VERIFICATION REPORT OF AFFORESTATION IN EUCALYPTUS AND ACACIA PLANTATIONS FOR BURAPHA AGROFORESTRY CO., LTD.

Project Title	Afforestation in Eucalyptus and Acacia plantations for Burapha Agroforestry Co., Ltd.
Version	3.5
Report ID	VCS.VER.23.33

Report Title	Verification Report of Afforestation in Eucalyptus and Acacia plantations for Burapha Agroforestry Co., Ltd.
Client	Burapha Agro-Forestry Co. Ltd
Pages	72

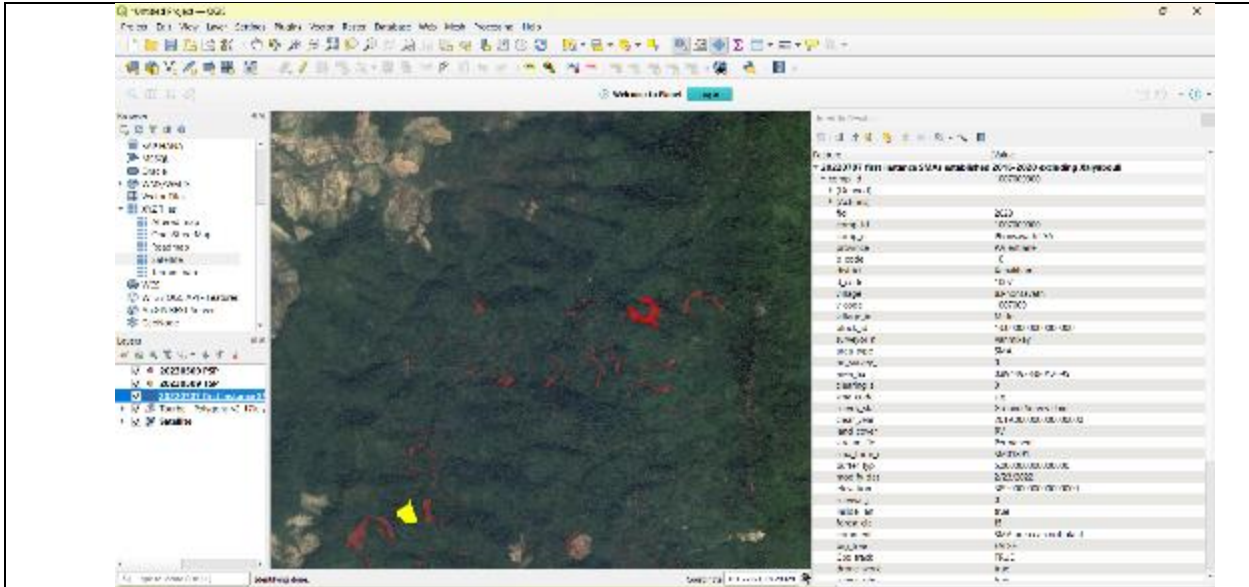
1. PP is requested to clarify why do the majority of the Permanent Sample Plots (PSP) and Temporary Sample Plots (TSP) points fall outside the boundaries of the project activity area?

Project participant response	Date : 16/01/2024
<p>The VVB has mistakenly used the SMA shapefile as the plantations instead of the plantation shapefile. Please be sure to use the shapefile "20230922 first instance stands developed 2016-2020 excluding Paklay.zip"</p>	
Documentation provided by project participant	
VVB assessment	Date: 22/02/2024
<p>CL#05 stands open. The open issue is pertaining to the precision of mean annual increment (MAI) and the calibration of growth rates. PP is requested to provide clarification regarding the methodology employed for the calibration of these crucial metrics, particularly given the absence of a singular</p>

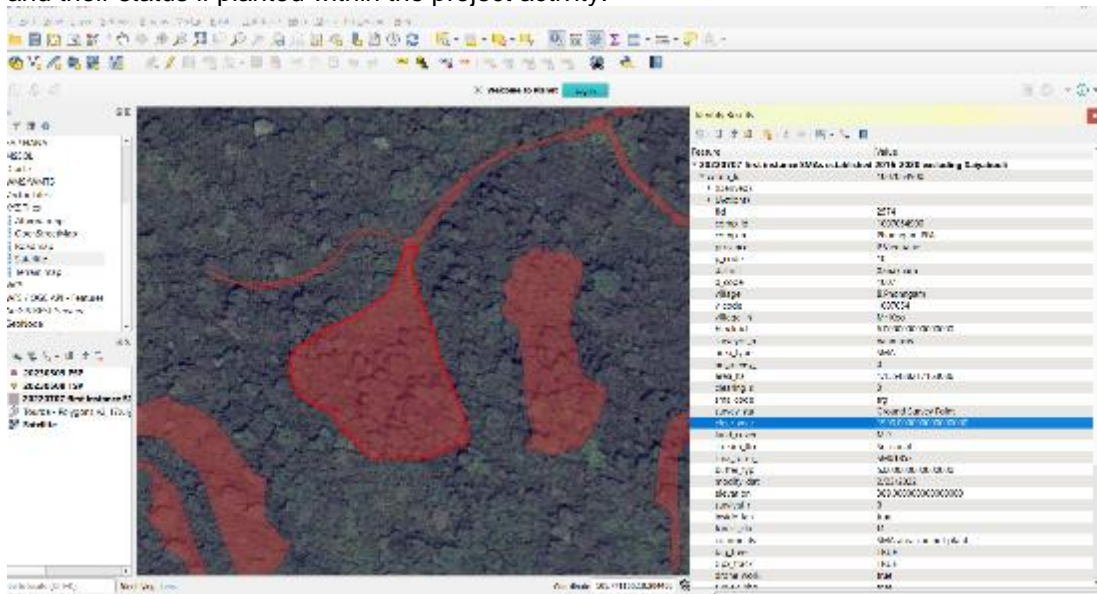
2. In some patches, the absence of PSP (Permanent Sample Plots) and TSP (Temporary Sample Plots) raises concerns about the accuracy of mean annual increment (MAI) and growth rate calibration. PP is requested to provide clarification on how these important metrics are calibrated without a single representation of the area. Additionally, it's unclear to which strata this area belongs, and clarification is also requested in this regard.

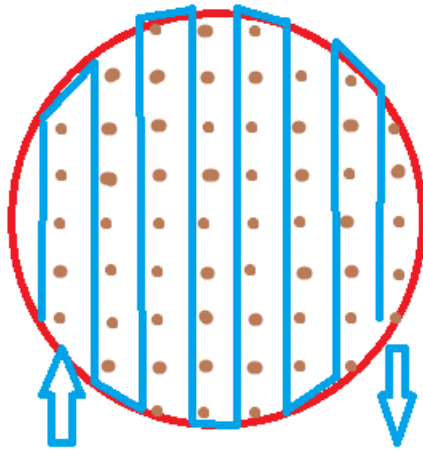
It has been explained during the site visit that the PSPs are marked through ribbons and TSPs are marked through paints. However, PSP 263 and TSP 4618 were not marked properly and were

identified through geo-coordinates. PP shall explain what the monitoring measures are placed to avoid these errors.	
Project participant response	Date : 29/07/2023
<p>(1) <i>The procedures followed for establishment of PSPs in the past are available in “Procedures of PSP”. Note that these procedures will be superseded by the “Draft Mensuration Procedure 2023”. In the past circular PSPs were established with a radius of 17.84m and a total area of 0.1 ha (0.0999 ha). In the future, if PSPs are established they will follow the new procedure, which species 40m x 40m plots (0.16 ha). TSPs are established in accordance with “Draft Mensuration Procedure 2023” which specifies 0.05 ha circular plots. The PSP and TSP procedures (i.e. from the new “Draft Mensuration Procedure 2023”) have been added as appendices to the MR.</i></p> <p>(2) <i>Please see response (1) above.</i></p> <p>(3) <i>Reference to the calibration manual “Vertex_IV_Manual” has been added to the MR in Section 6.</i></p> <p>(4) <i>Please refer to Section 6 and Section 7 of the MR.</i></p> <p>(5) <i>Data for PSP 263 has been deleted. Please see the updated monitoring calculations “Burapha_Second_Monitoring_Calculation_280723”</i></p> <p>(6) <i>The trees in TSP 4618 are the same age class, although variability in terms of thriving occurs, which can explain differences in the size of trees of the same age class. The Draft Mensuration Procedure 2023 states the following procedures</i></p> <ul style="list-style-type: none"> • <i>Dead or broken trees without a crown, or without any live branches, must be excluded from the enumeration.</i> • <i>In case of ovality (elliptical stems) or deformation of the stem, the side with the smallest DBH must be measured as DBH.</i> • <i>All planted stems must be measured provided the DBH is ≥ 5 cm. This number can be adjusted by the planning team according to the age of the stand being measured. If the stand only contains small trees, then all trees should be measured. If the stand in general have trees of much larger DBH, say 20cm, then small trees less than 5cm may be ignored during the enumeration. The purpose is to eliminate measurement of stems that will obviously not contribute volumes at clearfelling.</i> • <i>Do not measure if the tree is a different species to the main stand.</i> • <i>In case of double stems in one planting pit, measure only the largest DBH.</i> • <i>If a fork occurs under breast height (1.3 m), then measure only the largest DBH.</i> • <i>In coppiced stands for trees with multiple stems, measure the stem with the largest DBH for stem counting.</i> • <i>In case of double stems in one planting pit, measure only the largest DBH.</i> • <i>If a fork occurs under breast height (1.3 m), then measure only the largest DBH.</i> • <i>In coppiced stands for trees with multiple stems, measure the stem with the largest DBH for stem counting.</i> <p>(7) <i>Circular PSPs (ie the recent practice) are marked with a PSP plot centre (a 40cm PVC pole with aluminium tag). Trees surrounding the PSP plot centre, and boundary trees are also marked with an aluminium tag, creating three ways of identifying the PSPs.</i></p> <p><i>In the case of PSP 263 the plot centre marker had been destroyed by a tractor, however the surrounding and boundary trees were still tagged, allowing identification of the plot centre (confirmed with geo-coordinates). This was an example of how plots can still be identified, even if markers or tags are missing/destroyed.</i></p> <p><i>For TSPs the following process is followed, which allows identification of the plot centre, surrounding centre trees, plot boundary and boundary trees, even if markers etc are removed/destroyed (please refer to Appendix 3, Section 3.4 & 3.5 of Draft mensuration procedures):</i></p>

- All plot centres located in the field are to be clearly marked with a painted stick, which should be no less than 0.3 m tall. The colour of the paint must be clearly visible, e.g., yellow, orange or white.
- The non-marked tree closest to the plot centre should be clearly numbered with the plot number, facing the direction of the cruising line. If plots are not marked, the enumeration will have to be repeated.
- The four trees surrounding the plot centre are marked with and 'X' using spray paint.
- The transponder pole must be placed vertically at the plot centre when laying out a plot to determine the plot diameter.
- The centre point of each plot must be captured with the GPS and numbered accordingly.
- Tree measurement pattern
- Measure the trees in the plot tree by tree and row by row following the below pattern.

- The plot boundary should be established by using a Vertex. The trees within the plot radius (distance from the Vertex to Transponder) fall inside the plot and must be measured. Border trees are located on the plot boundary and are marked with a single ring using spray paint. At least two Vertex readings must be taken on both sides of the tree to determine if it falls inside the plot or not.
- When the distance reading is taken with the Vertex, the Vertex must be held at the centre of the tree's DBH and must face towards the transponder.

This information has been added to Section 6 in the MR.

Figure 1: Project area KML with PSP & TSP

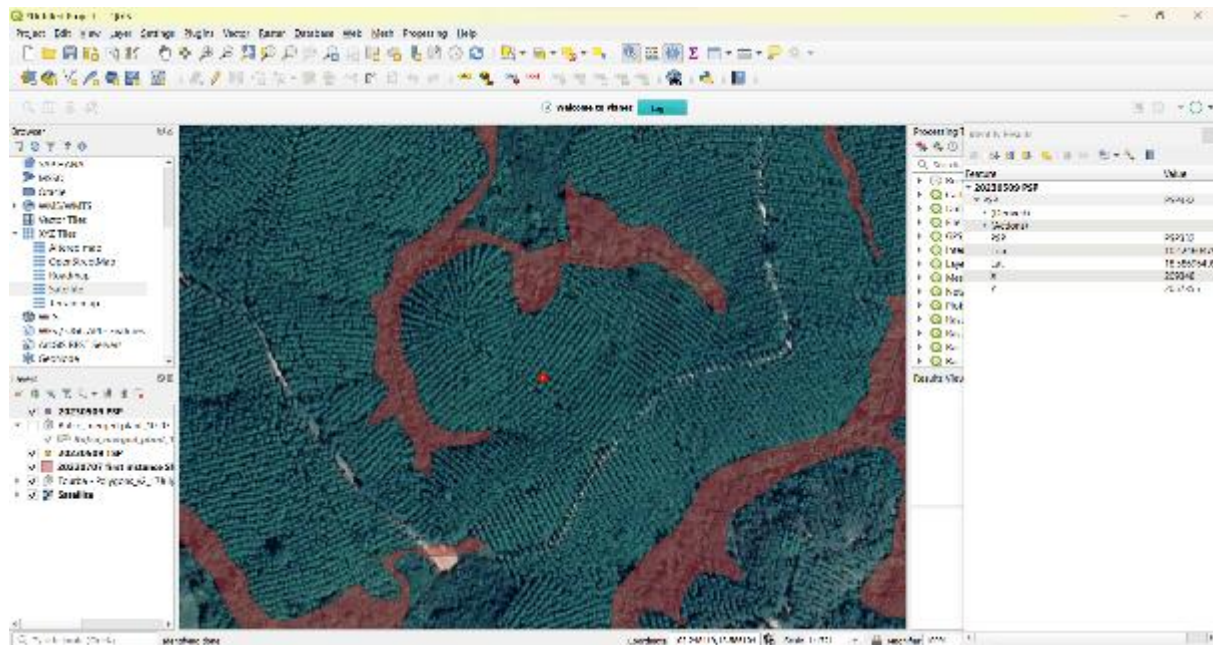
During the site visit on day 1, it was observed that the two Permanent Sample Plots (PSP) are located in close proximity, with only a few trees between them. However, it was noted that only one PSP (PSP ID: PSP332) is present in the KML and PSP & TSP vector files. Furthermore, the PSP falls outside the project activity area. PP is requested to provide clarification regarding this inconsistency.
